Grid Code Review Panel: 8th June, 2011

**MPID 215: Changes to CC.7.3.1.1(h) Proposed by
Fault Ride Through Working Group**

Fault Ride Through Working Group (FRTWG)

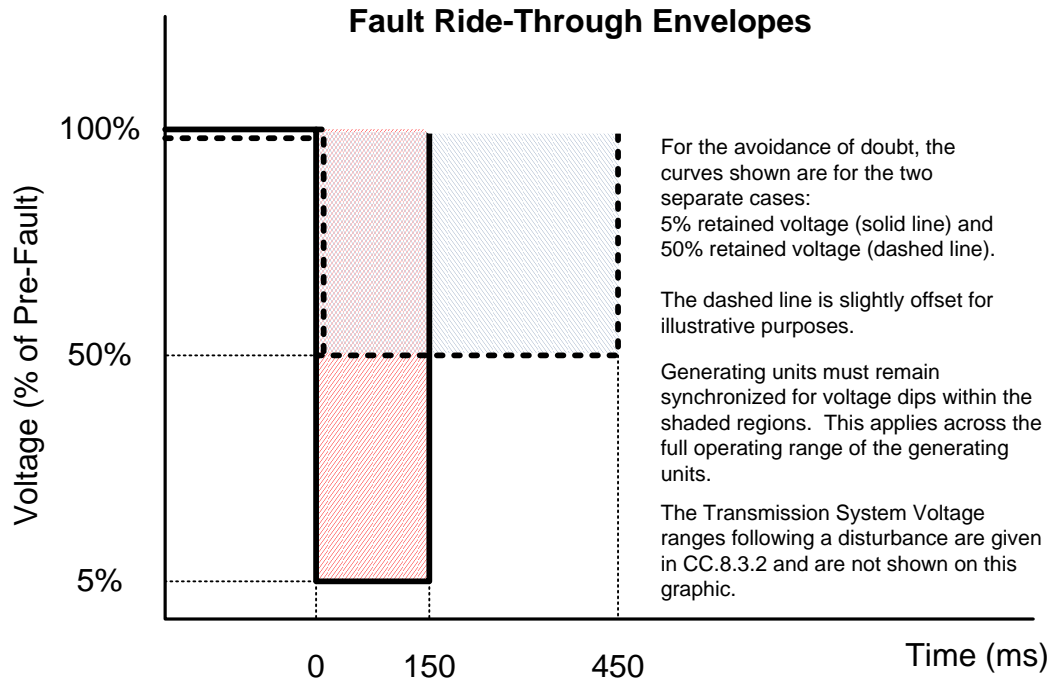
Any changes to CC.7.3.1.1 with supporting documentation: history, technical justification, impacts

*Apply over the full operating capabilities of the **Generation Unit at the Connection Point.**
